## Workhorse Re-assembly

Date: August 20, 1999

The technical manual did not detail how to tighten the end-cap and transducer hardware.

All Workhorse and Rio Grande ADCPs

**Figure 1. End-Cap Mounting Hardware**

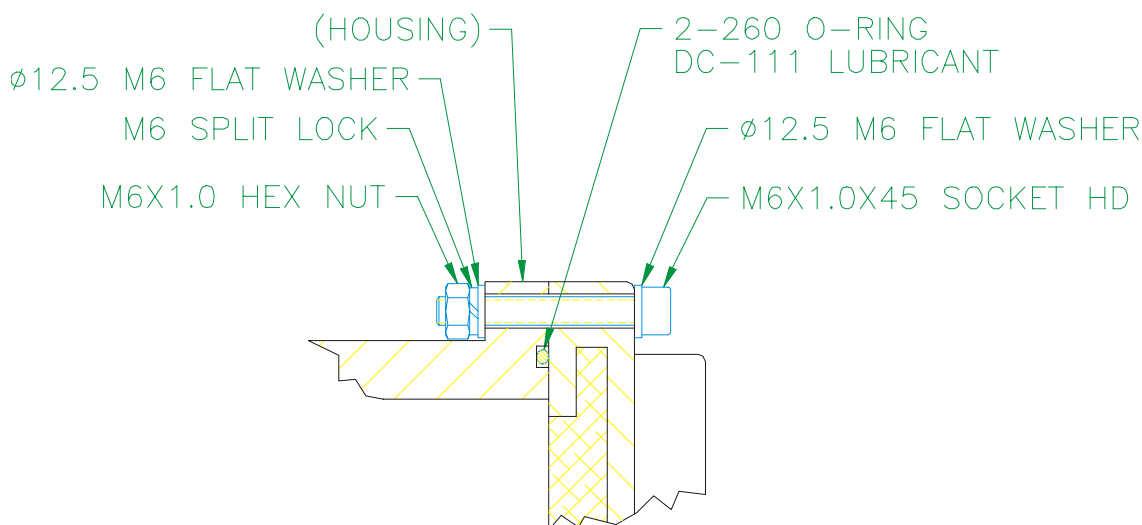
- d. Examine the end-cap assembly nuts, bolts, and washers (6 mm) for corrosion; replace if necessary. [Figure 1](#) shows the assembly order of the end-cap mounting hardware. *All* the hardware items are needed to seal the Workhorse properly.
- e. Install all four sets of hardware until “finger-tight.”
- f. Tighten the bolts in small increments in a “criss-cross” pattern until the split washer flattens out, and then tighten each bolt ¼ turn more to compress the face seal O-ring evenly. Tighten the bolts to the recommended torque value of 5.6 Newton-meters (50 pound-inches).

**CAUTION.** Apply equal pressure to the O-rings as you tighten the bolts. If one bolt is tightened more than the others, the O-rings can become pinched or torn. **Damaged O-rings will cause the system to flood.**

**CAUTION.** Do not over tighten the bolts that hold the transducer, housing and end cap together. If you tighten too far, you can crack or break the plastic bushing. On the other hand, **leaving the bolts too loose can cause the system to flood.** Tighten the hardware to the recommended torque value.

**NOTE.** The recommended torque value for the end-cap 6mm bolts is 5.6 Newton-meters (50 pound-inches).

**Figure 2. Transducer Mounting Hardware**

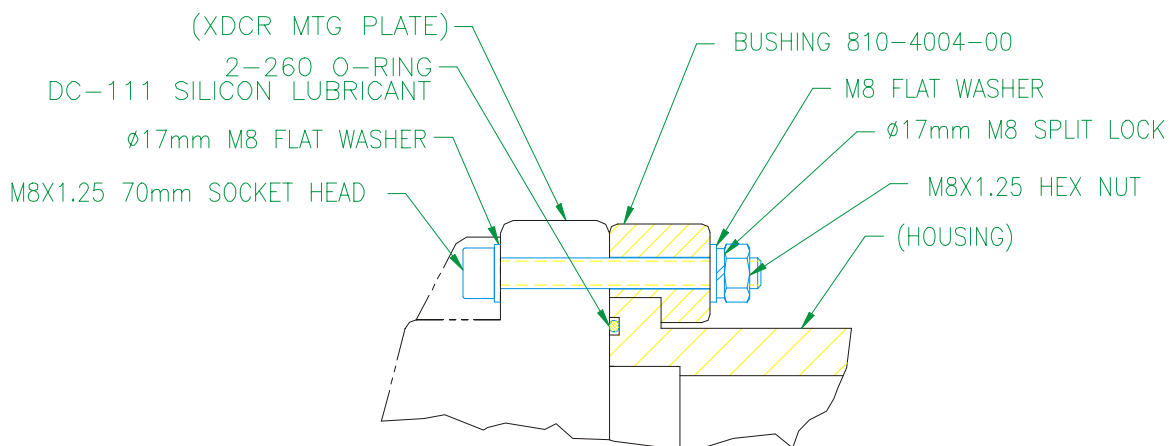
- Examine the transducer assembly nuts, bolts, and washers (8 mm) for corrosion; replace if necessary. [Figure 2](#) shows the assembly order of the transducer mounting hardware. *All* hardware items are needed to seal the Workhorse properly.
- Install all four sets of hardware until “finger tight.”

- f. Tighten the bolts in small increments in a “criss-cross” pattern until the split washer flattens out, and then tighten each bolt  $\frac{1}{4}$  turn more to compress the face seal O-ring evenly. Tighten the bolts to the recommended torque value of 9.6 Newton-meters (85 pound-inches). Do not deform the plastic bushings.

**CAUTION.** Apply equal pressure to the O-rings as you tighten the bolts. If one bolt is tightened more than the others, the O-rings can become pinched or torn. **Damaged O-rings will cause the system to flood.**

**CAUTION.** Do not over tighten the bolts that hold the transducer, housing and end cap together. If you tighten too far, you can crack or break the plastic bushing. On the other hand, **leaving the bolts too loose can cause the system to flood.** Tighten the hardware to the recommended torque value.

**NOTE.** The recommended torque value for the transducer head 8mm bolts is 9.6 Newton-meters (85 pound-inches).
